**ADDENDUM NO. 3**

FOR: WEBB COUNTY YOUTH VILLAGE REHABILITATION CENTER  
FOR WEBB COUNTY  
111 CAMINO NUEVO ROAD, HWY 359  
LAREDO, TEXAS 78041

ADDENDUM DATE: July 6, 2016

ARCHITECTS PROJ. NO.: 1401

AE3.1-A  
DATE: JUNE 29, 2016

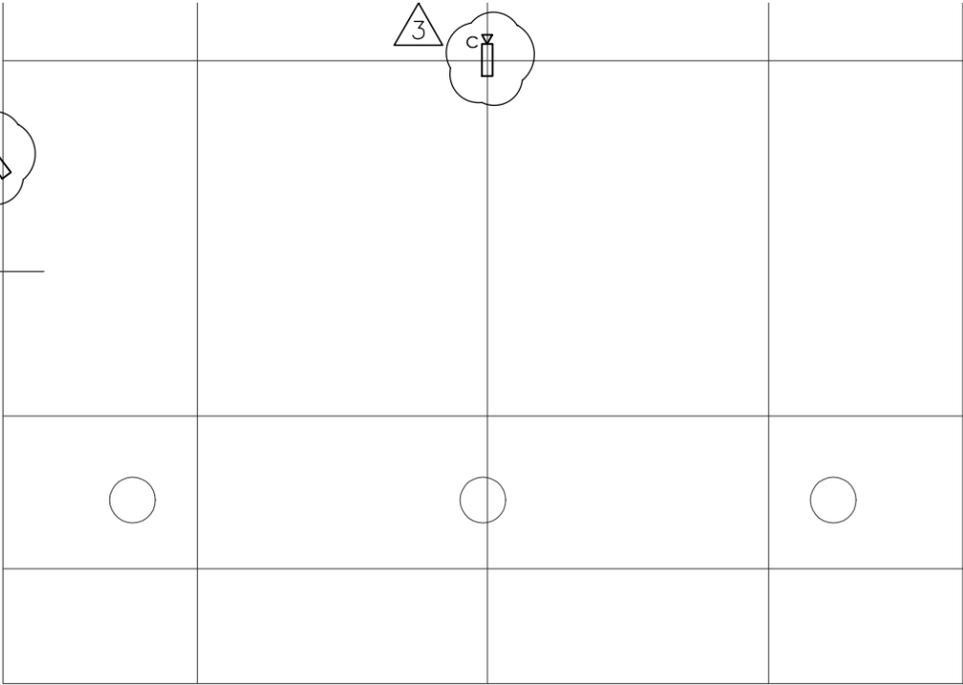
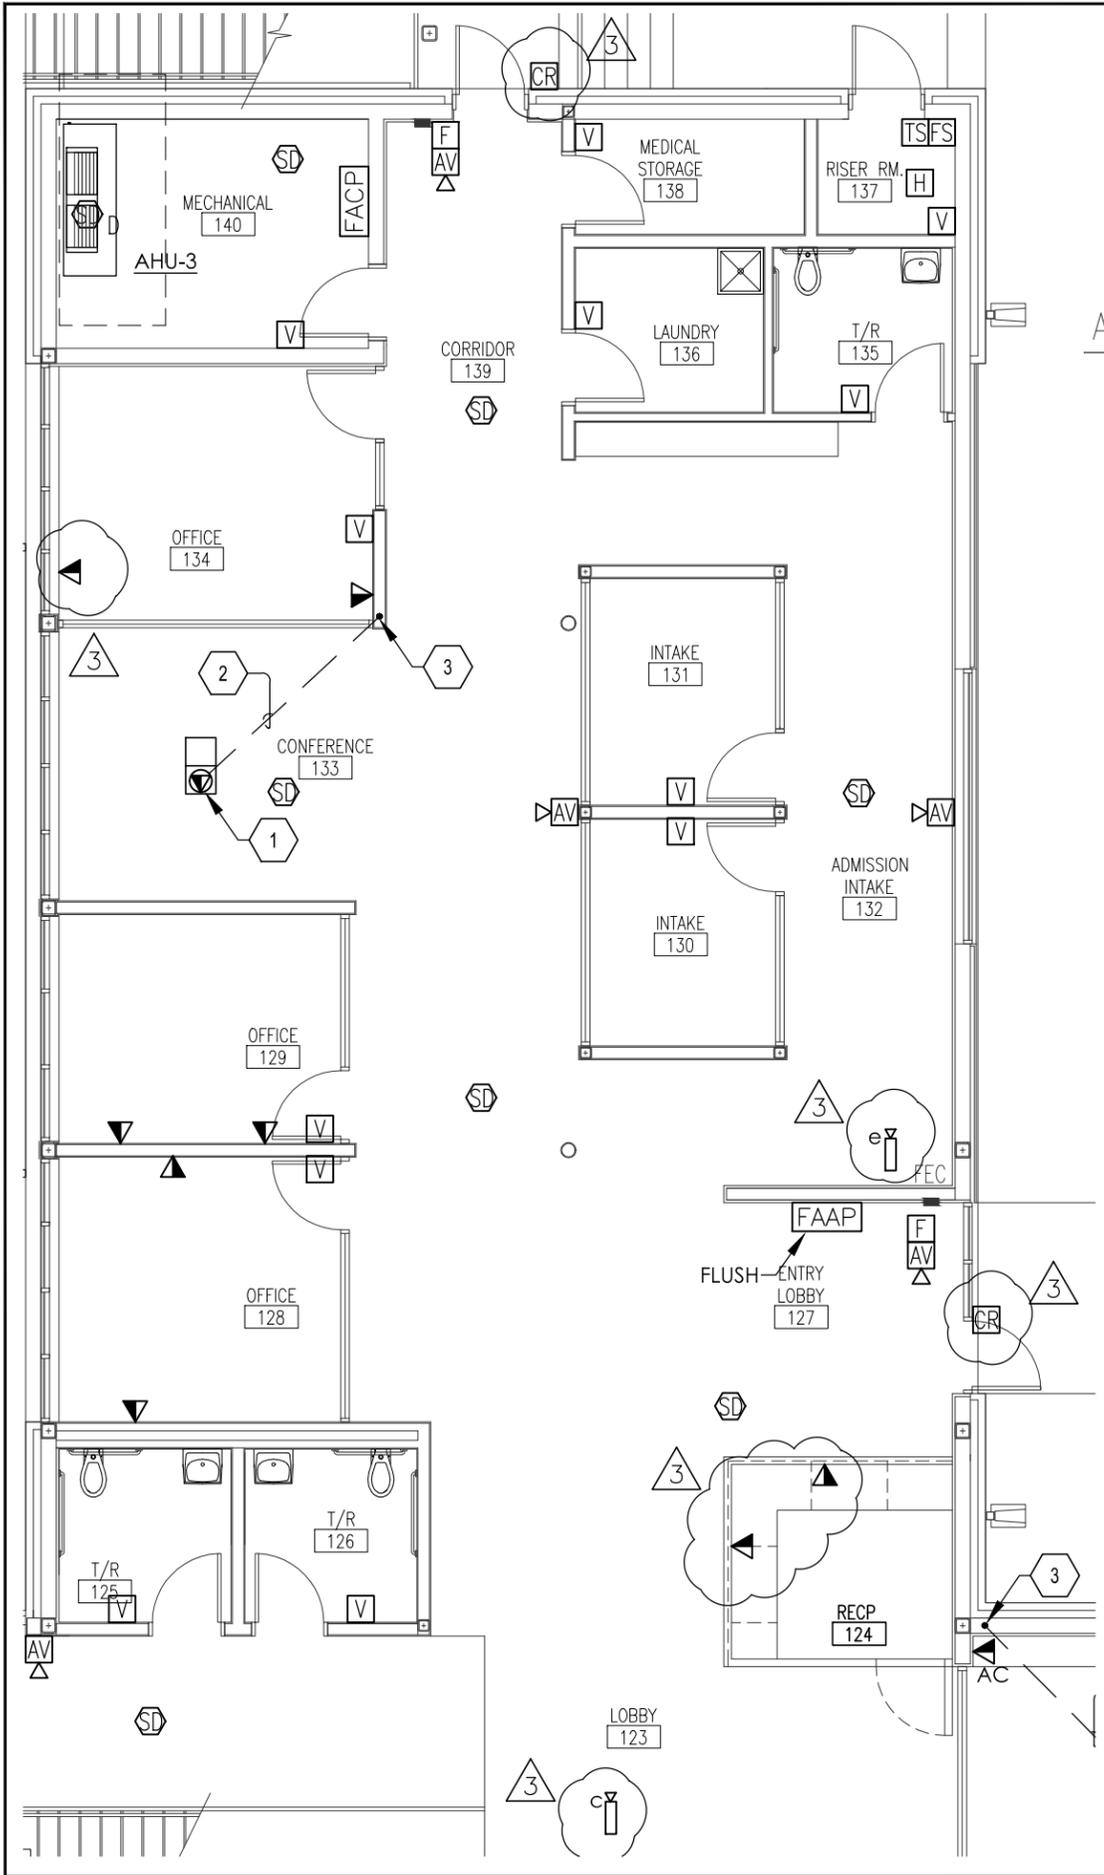
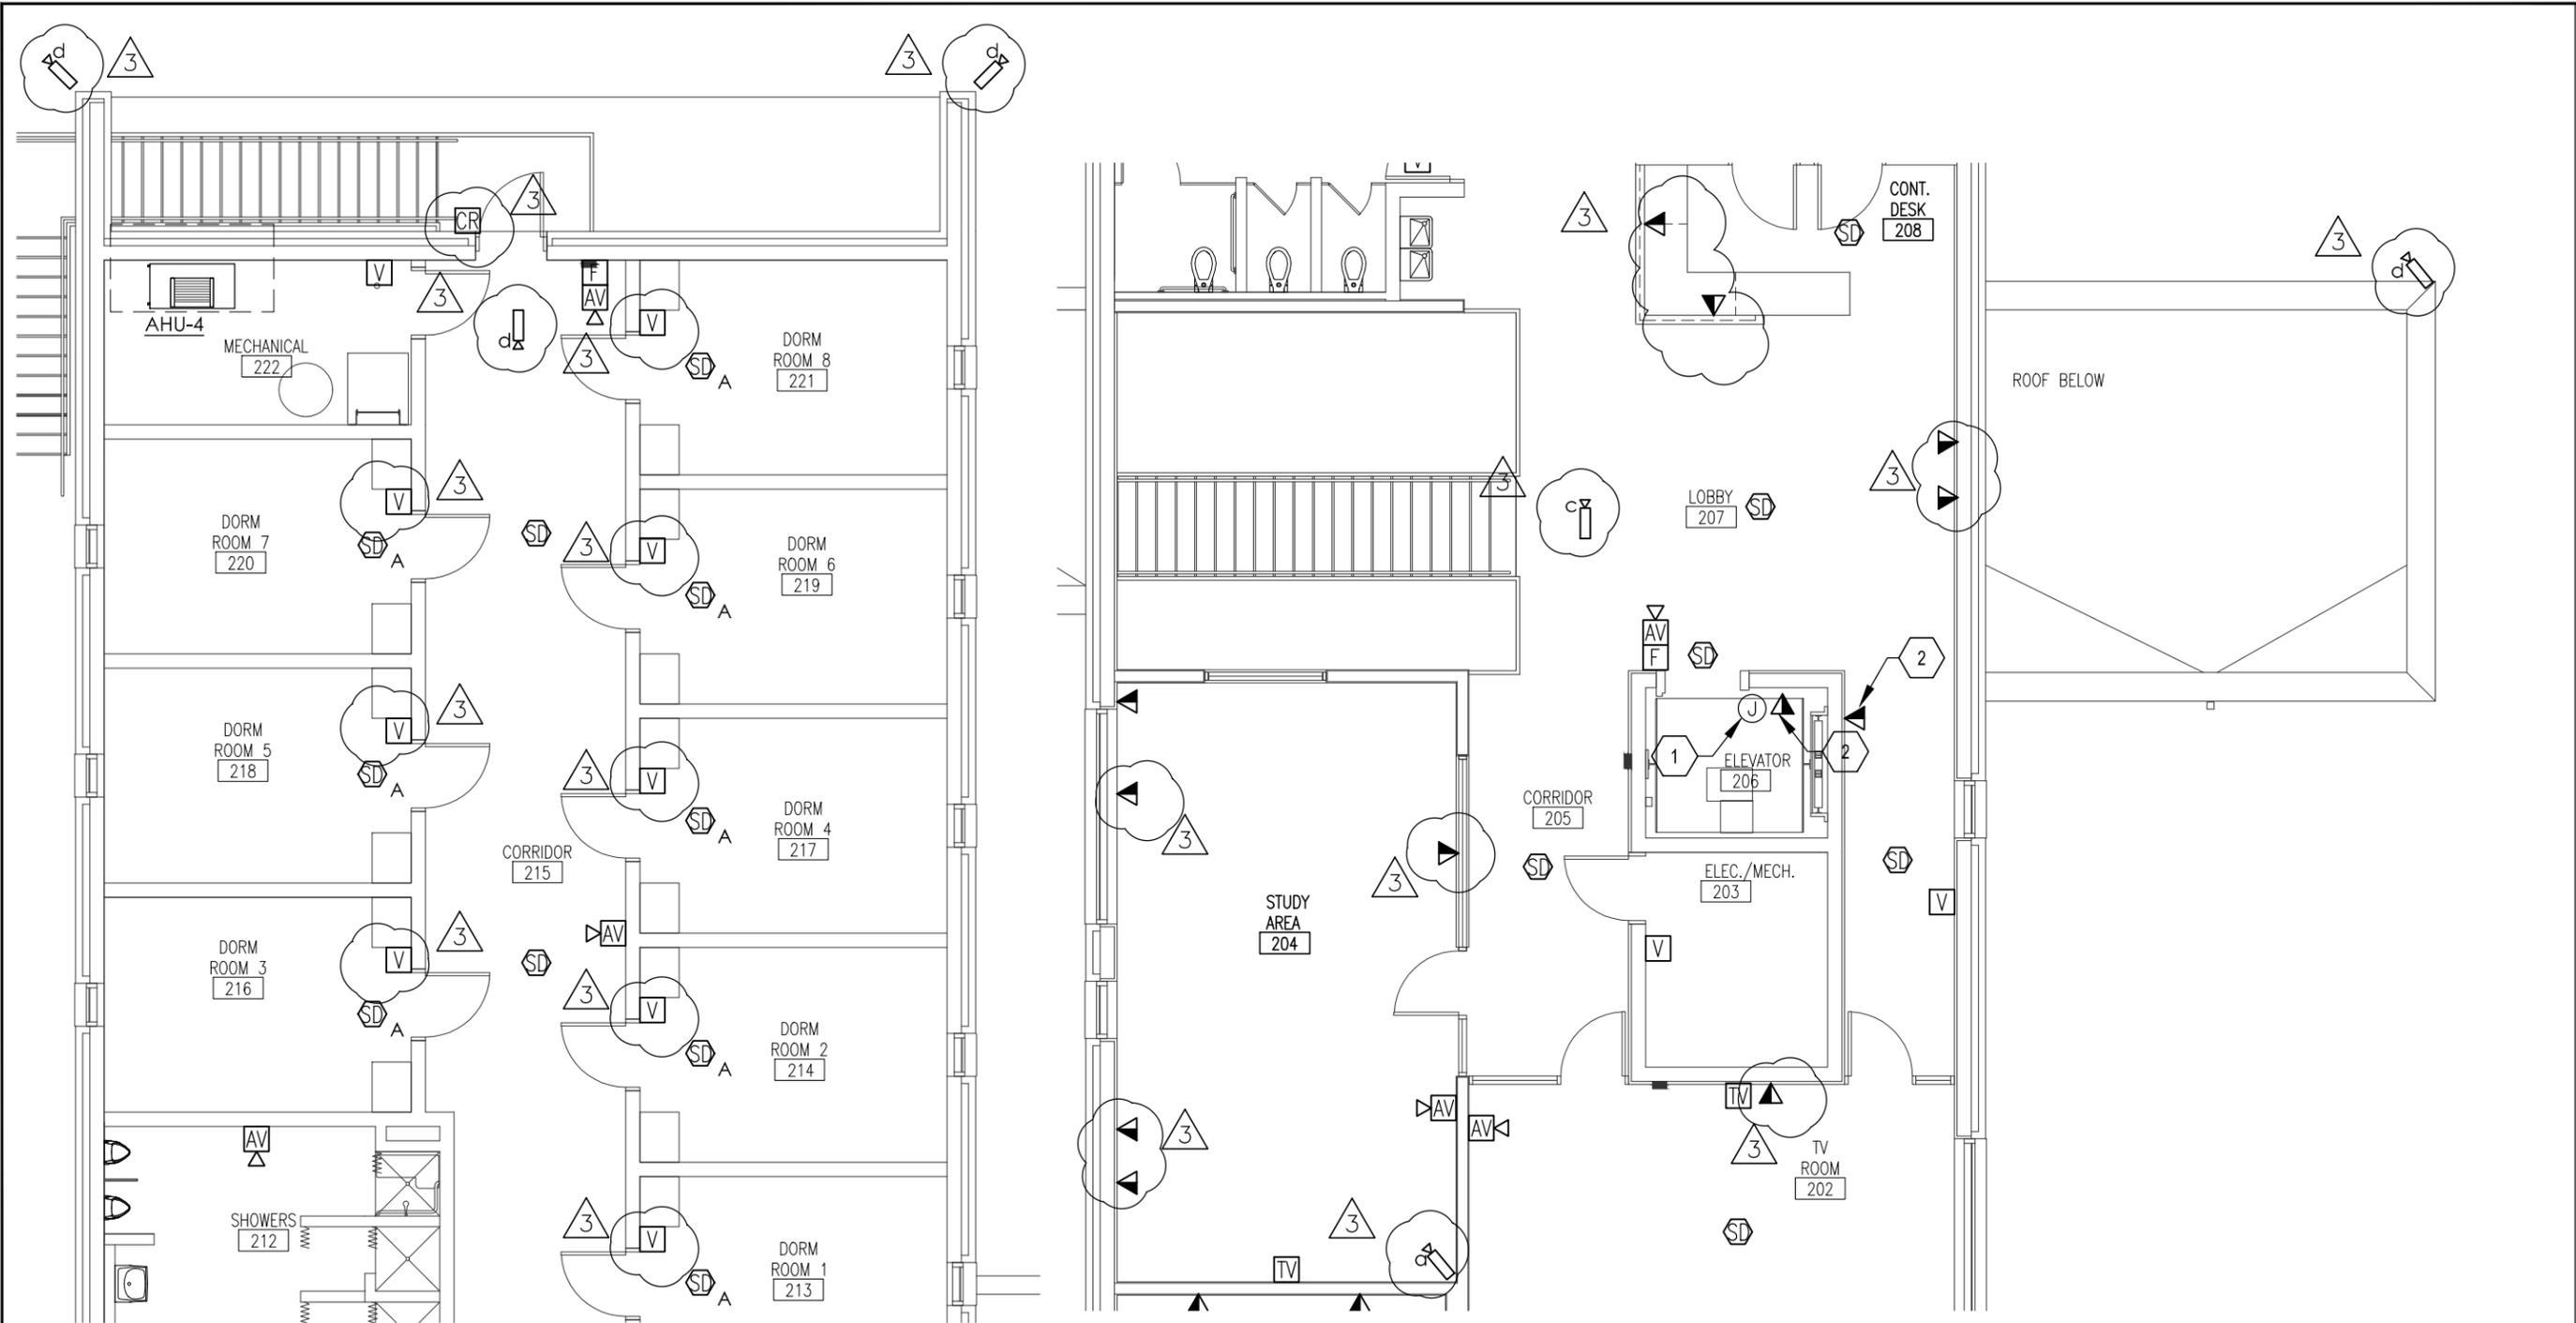
D3-9	E3.1	<ol style="list-style-type: none"><li>1. Revise as shown in attached sheets AE3.1-A &amp; AE3.1-B</li><li>2. Add General Notes: Special Systems, items I &amp; J; refer to attached AE3.1-A</li><li>3. Add Surveillance Camera Legend; refer to attached AE3.1-B</li></ol>
D3-10	E3.2	<ol style="list-style-type: none"><li>1. Revise as shown in attached sheets AE3.2-A &amp; AE3.2-B</li><li>2. Relocate Tel/ Data outlets; refer to attached sheets AE3.2-A &amp; AE3.2-B</li><li>3. Add General Notes: Special Systems, items I &amp; J; refer to attached AE3.2-B</li><li>4. Add Surveillance Camera Legend; refer to attached sheets AE3.2-B</li></ol>
D3-11	E4.1	<ol style="list-style-type: none"><li>1. Revise as shown in attached sheets AE4.1</li><li>2. Revise Electrical legend, Luminaire Schedule; refer to attached AE4.1.</li><li>3. Add relay Lighting Control Panel Schedule and Occupancy Sensor Legend; refer to attached AE4.1.</li></ol>

SHEET NO.  
**AE5.2**  
DATE: JUNE 29, 2016

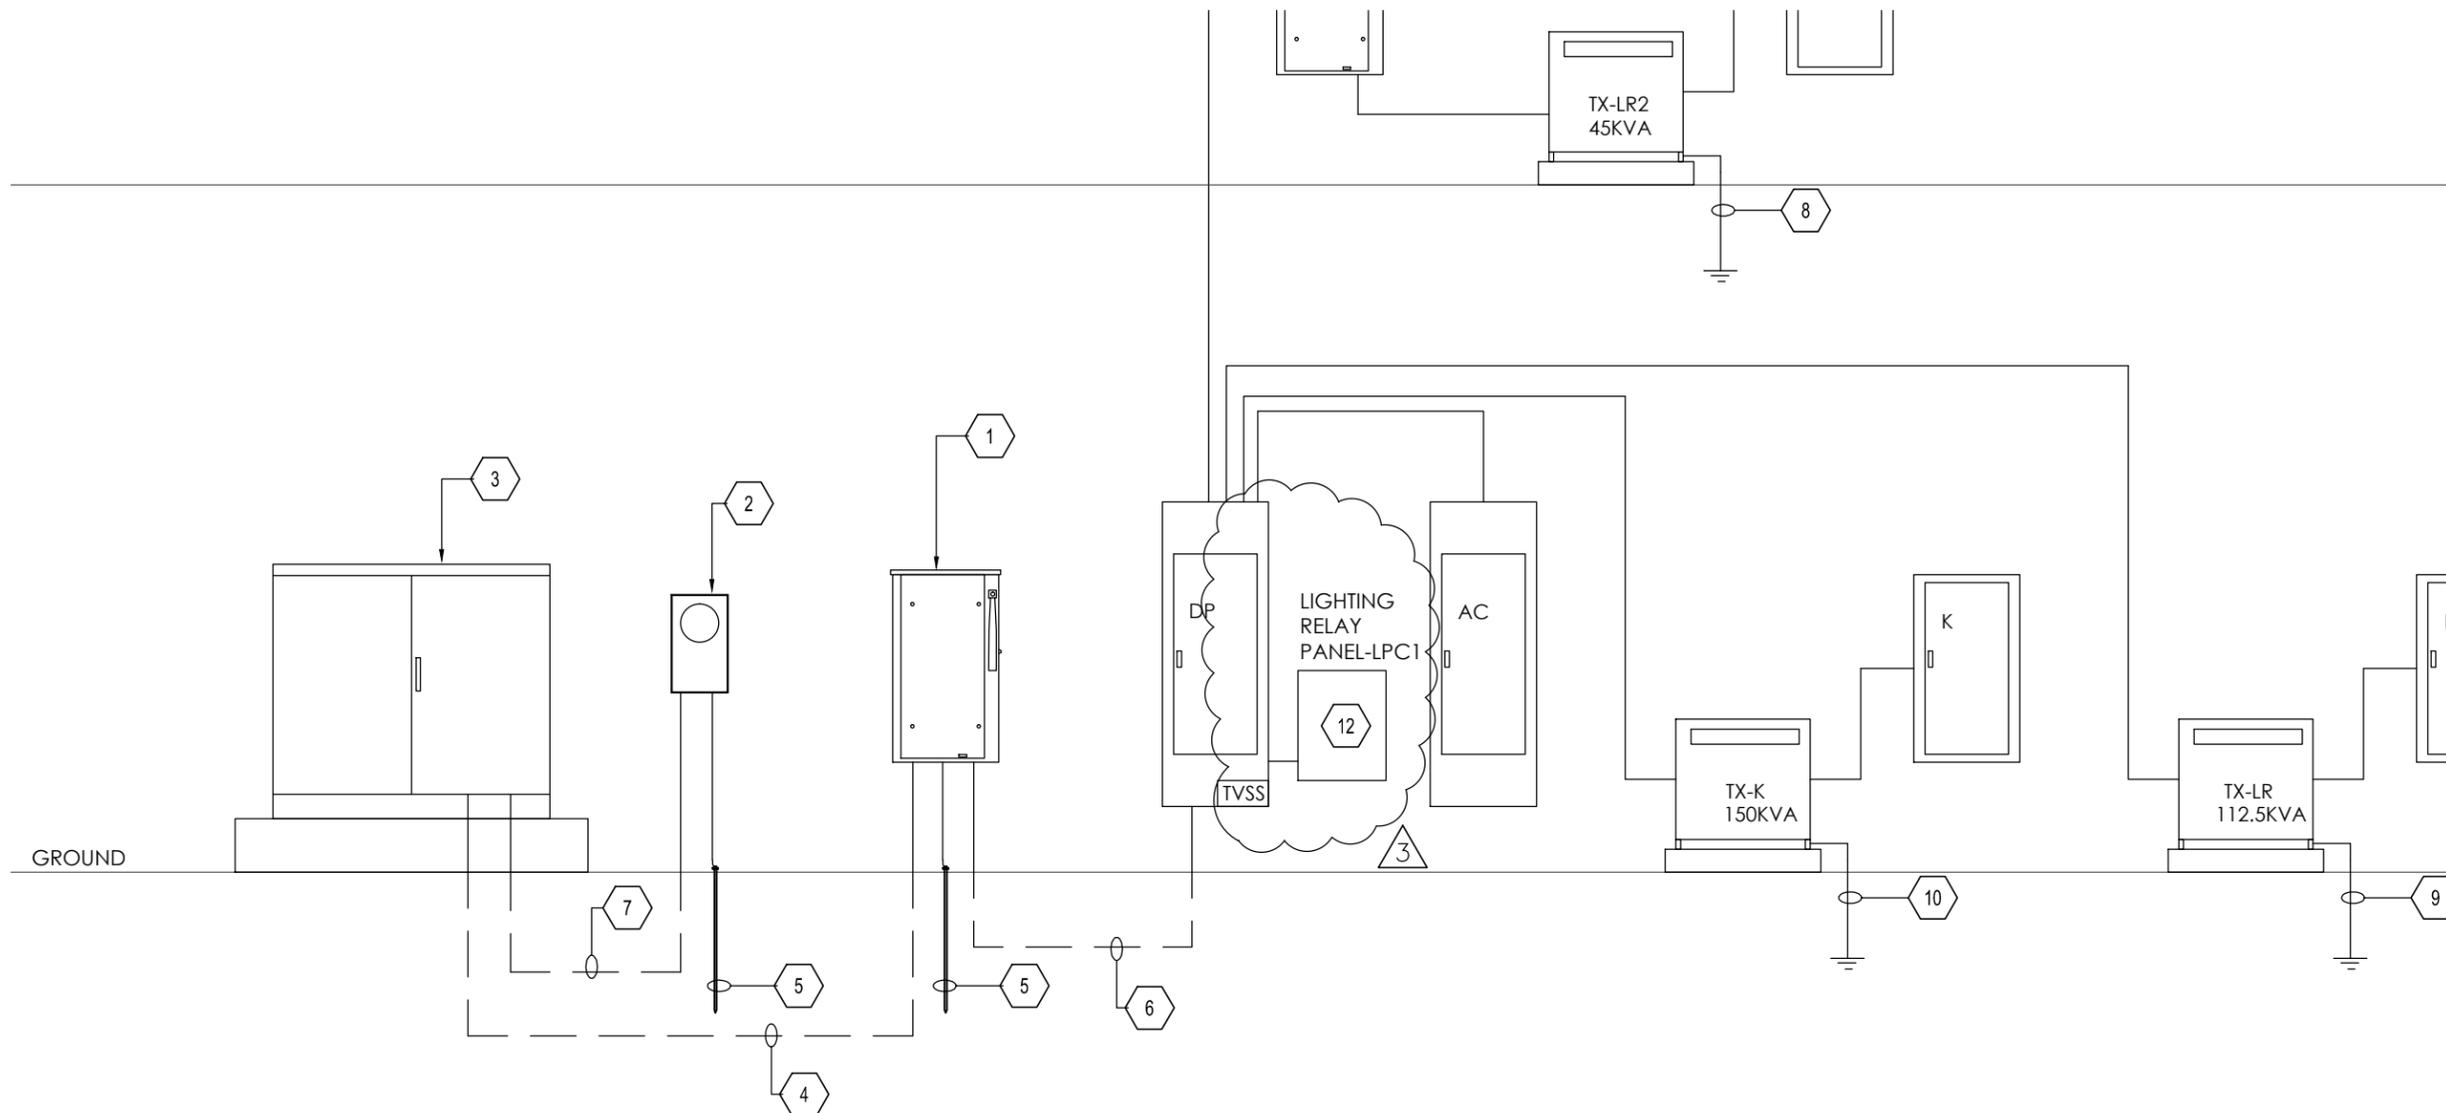
D3-12	E5.1	<ol style="list-style-type: none"><li>1. Revise as shown in attached sheets AE5.1</li><li>2. Add Electrical Riser Diagram Keyed Notes, item 12; refer to attached sheet AE5.1</li></ol>
D3-13	E5.2	<ol style="list-style-type: none"><li>1. Revise Electrical Panel Schedules; refer to attached AE5.2</li></ol>
D3-14	P1.1	<ol style="list-style-type: none"><li>1. Revise Electrical Panel Schedules; refer to attached AP1.1-A</li></ol>
